Lifetime extension of the  
French 1300 MWe reactor fleet  
Generic requirements for the  
periodic safety review 4

Expert statement – synthesis report

**Project Manager** Franz Meister (Umweltbundesamt)

**Contracting authority** Federal Ministry for Climate Action, Environment, Energy, Mobility, Innovation and Technology, Directorate General VI – Climate Action and Energy, Directorate VI/8 – General Coordination of Nuclear Affairs

**Figure 3:**  
Active fault map of  
metropolitan France and  
locations of 1300 MWe  
reactor sites.

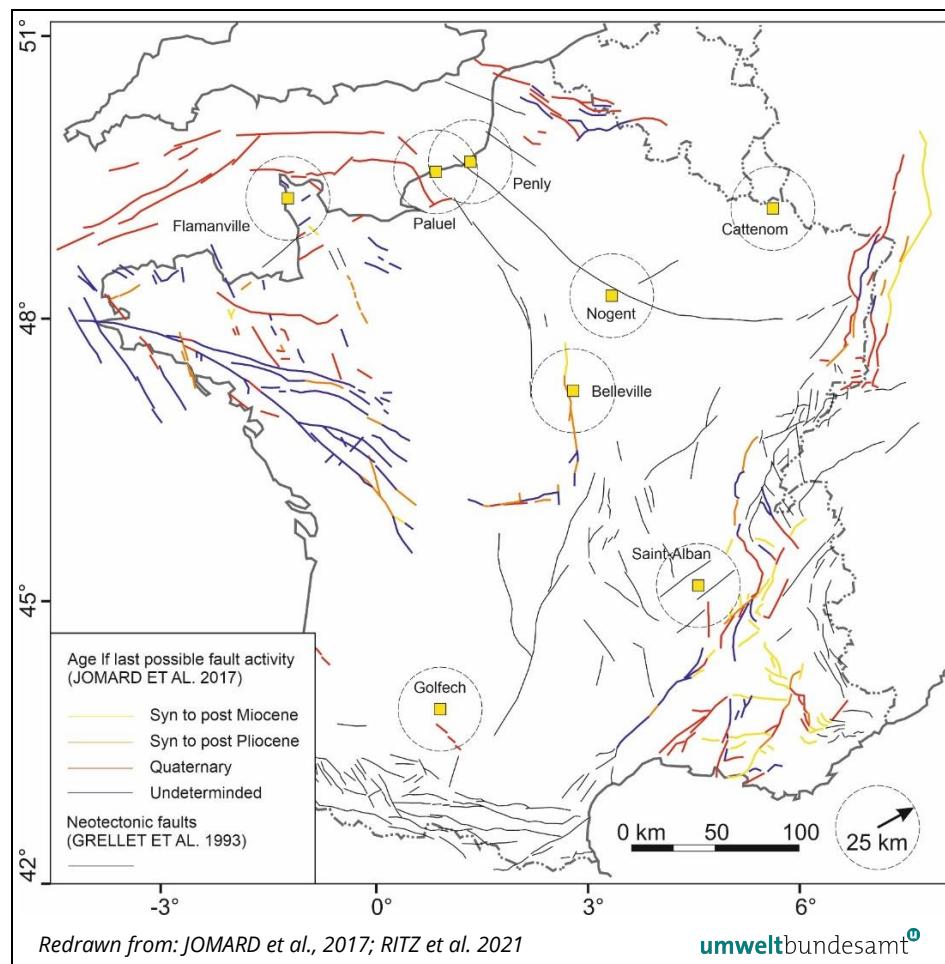
Figure 3 shows the locations of the 1300 MWe reactors on the background of the French active fault database. The importance of considering fault information is particularly evident for the sites Belleville, Flamanville, Golfech, Paluel and St. Alban, where Pliocene and/or Quaternary faults extend to distances of less than 25 km from the plants. It is noteworthy in this context that ASN has already prescribed how to incorporate fault data in the PSHAs for establishing the HSC of the 900 MWe reactors Fessenheim and Tricastin (ASN 2018).
